DOCKETED	
Docket Number:	24-BPS-01
Project Title:	Building Energy Performance Strategy Report
TN #:	271878
Document Title:	Jamy Bacchus Comments - Comments on the CEC Draft BPS Recommendations
Description:	N/A
Filer:	System
Organization:	Jamy Bacchus
Submitter Role:	Public
Submission Date:	8/7/2026 1:57:49 PM
Docketed Date:	8/7/2026

Comments on the CEC Draft BPS Recommendations

CALIFORNIA BUILDING ENERGY PERFORMANCE STRATEGY REPORT COMMENTS TO THE DRAFT REPORT

Figure 1: Whole Life Carbon framework and nomenclature

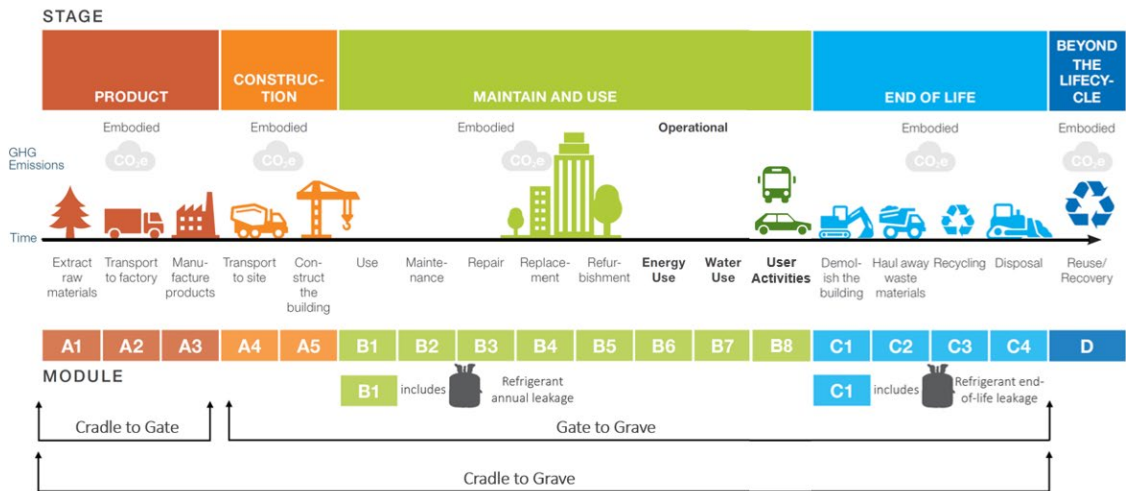
The draft report continues the longstanding omission of significant greenhouse gas emissions from the built environment.

Most notably, the draft report focuses almost exclusively on on-site combustion. The framework evaluates fossil fuels burned on-site, such as natural gas equipment and presumably fuel cells and microturbines used for electricity production.

The proposed on-site GHGi metric excludes the relationship between buildings and the electric grid. Electricity-related impacts include:

But these are just another facet of operational energy-related carbon emissions. BPS regulations historically omit any transit-related emissions, embodied carbon emissions, refrigerant leakage emissions, water and wastewater conveyance emissions.

Figure 2: The author's January 2022 public review comments of Energize Denver's draft regs

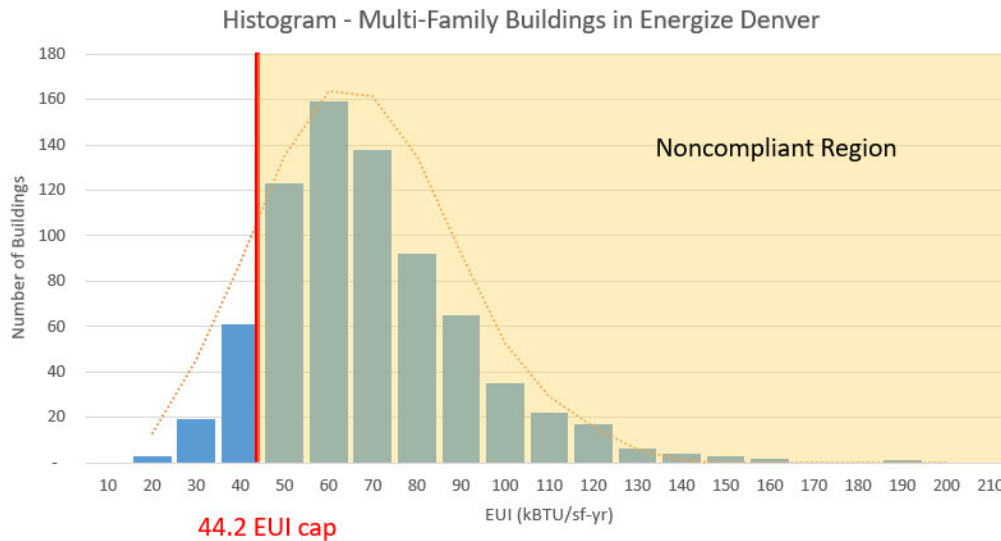
This assumes that every building within an occupancy category can ultimately achieve a fixed EUI target regardless of:

All that is needed are sufficient financial penalties to provide incentives for owners to achieve these targets, provided they have limited payback because the owners cannot recoup capital improvement costs from tenants. To label it overly simplistic would be an understatement.

This top-down assumption has never been adequately demonstrated. Even Denver's City Energy Project building awardees and Energize Denver project awardees for outstanding retrofits only had a pass rate of 27% versus the city's 15% pass rate when originally promulgated in January 2022.

Figure 4: Circa 2000 version of CAL-ARCH's benchmarking portal

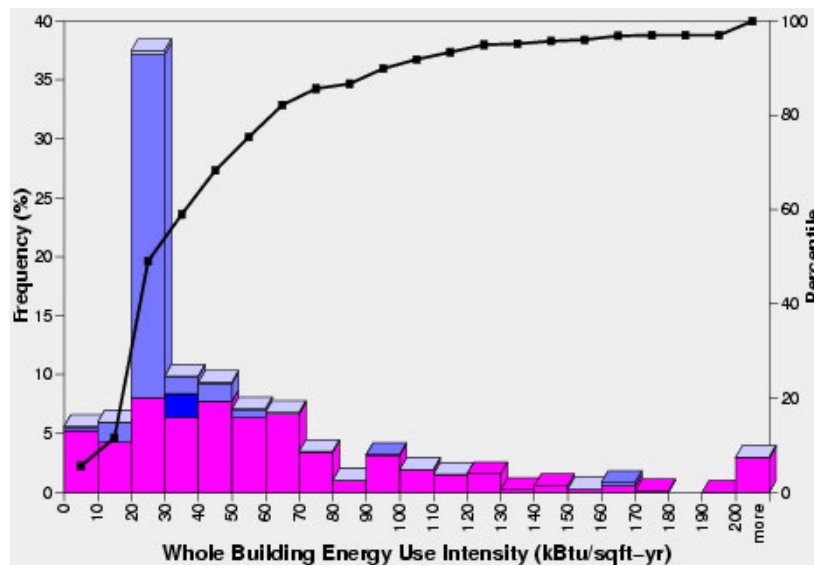
Compounding this issue, California no longer provides public analytical tools comparable to those previously available through the CEUS portal or CAL-ARCH, making it considerably more difficult for building owners to understand where their buildings fall relative to comparable facilities.

Without reliable benchmarking data, it is difficult to establish fair or technically defensible Building Performance Standards.

Figure 5: Group 14's analysis of self-reported data from owners vs data it had from energy modeling them while in design

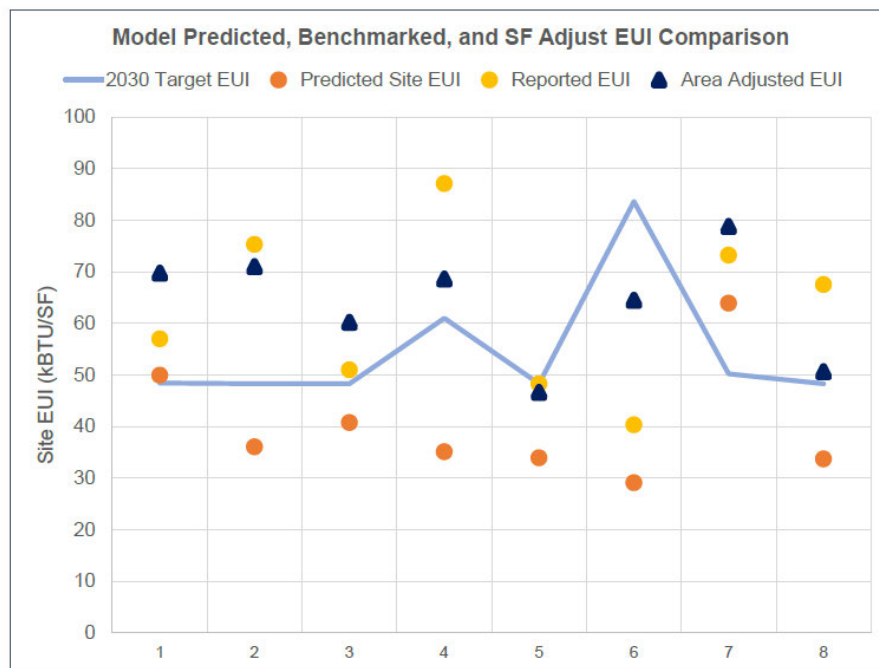
Group 14's work in Denver demonstrated that many recently constructed buildings required large corrections before they could even be categorized properly for projects built in the past decade.

Perhaps most alarming was that Denver when it worked with NBI to set its 15th percentile targets used unverified, self-reported data from its benchmarking database. That means the targets were set coincidentally about one standard deviation from the mean relying on data it did not confirm we actually real. It might be fair to assume that buildings closer to the median are real, but as properties fall into the extremes, these outliers should be regarded with higher levels of skepticism.

When floor area itself is uncertain by 20% or more, establishing compliance targets to the nearest tenth of a kBtu per square foot creates a false appearance of scientific precision. We are not gods; we need to stop the pretense

The Commission should recognize these limitations before adopting fixed numerical targets that exceed the accuracy of the underlying data.
